PROJECT: Area 15

CITY OF LAS VEGAS		DATE:
INTER-OFFICE MEMORANDUM		March 8, 2018
TO: Land Development Services Department of Building & Safety		FROM: Albert Sung, P.E. Flood Control Project Engineer Department of Public Works
SUBJECT:	Drainage Study for: Area 15	
Cross Streets:	SWC of Rancho Drive & Sirius Avenue	
File Number:	F:\Depot\DSMemos\DS4921D.doc	
Parcel Number:	162-08-418-002	
Zoning Action:	SDR-70652	
FEMA Flood Zone	YES	NO X
Proposed Storm Drain	YES	NO X
COPIES TO:		Kimley Horn and Associates, Inc. Integral Partners Park Center Las Vegas, LLC Bart Anderson, P.E., DevCo CCRFCFCD NDOT

Technical Drainage Study Supplement 2 to Addendum 1

This report is intended to serve as Supplemental Information to Addendum #1 for the Area 15 Project. The comments in a letter from the Clark County Regional Flood Control District dated February 14, 2018 (included as **Attachment A**) and comment responses are included below. The responses are provided in italics.

SHEET NUMBER
C3.1

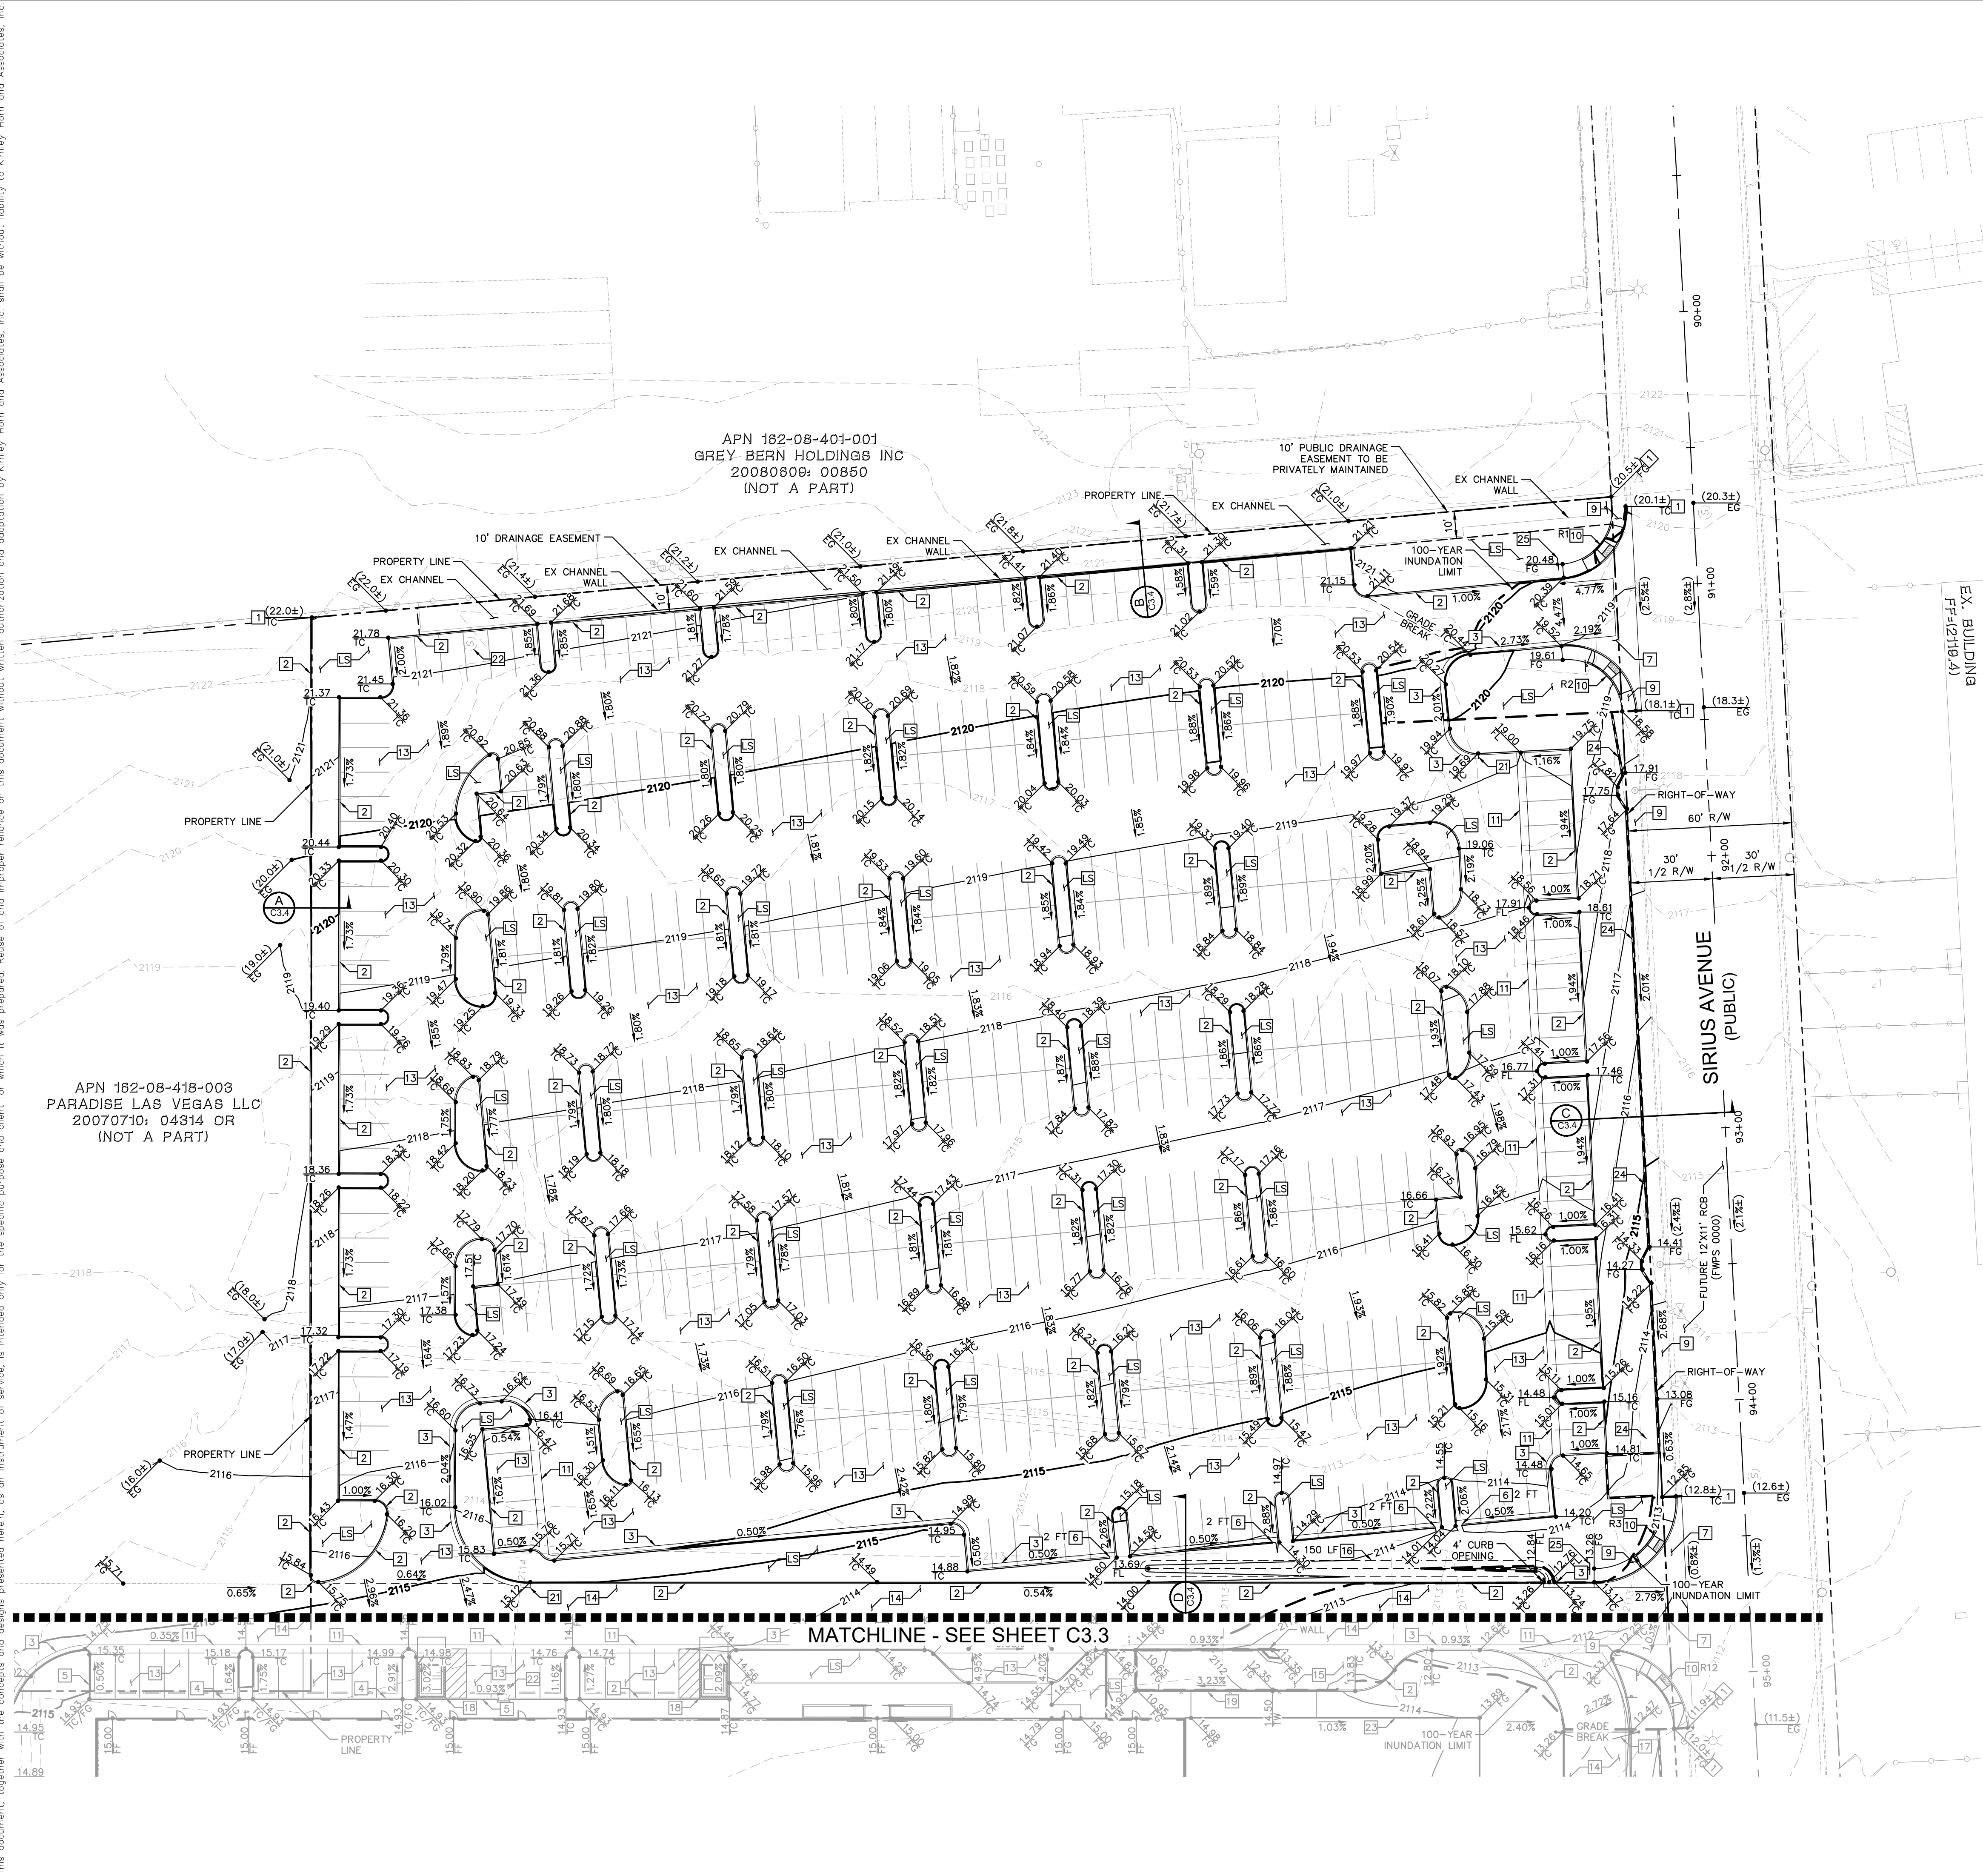
2. Label the existing Finished Floor elevations for the existing buildings on the north side of Sirius Avenue on Sheets C3.0, C3.1, and C3.3.

The plans have been revised per the comment.

STEM WALL DETAIL
NTS

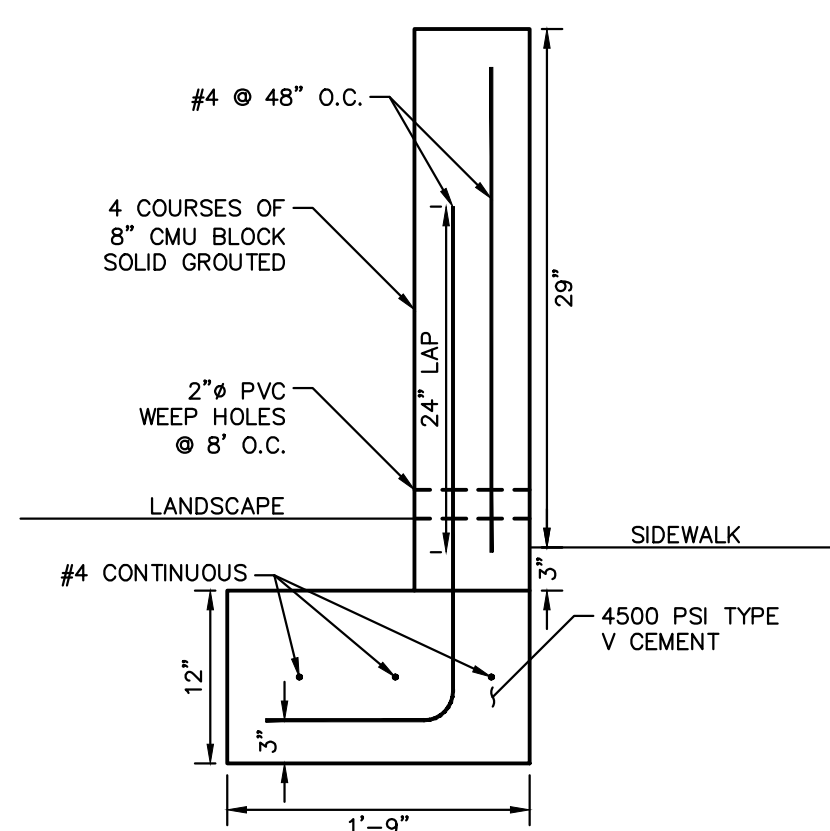
1. The project is proposing a 29" stem wall along Sirius Avenue that confines the flow to the right-of-way in order to protect the project site. However, this proposed improvement will potentially raise the water surface elevation on Sirius Avenue and may adversely impact the adjacent properties on the north side of the street and must be addressed. Per discussion with the City of Las Vegas, provide pre-development and post-project hydraulic analysis (HEC-RAS) for Sirius Avenue to ensure that the project does not impose a negative impact on adjacent properties.

*See **Attachment B** for the HEC-RAS analysis. The analysis shows little to no increase in most of the cross sections. The maximum increase, 0.39 ft occurs in the downstream-most cross section 1036. See **Attachment C** for an exhibit with the existing and proposed conditions flood inundation limits shown.*
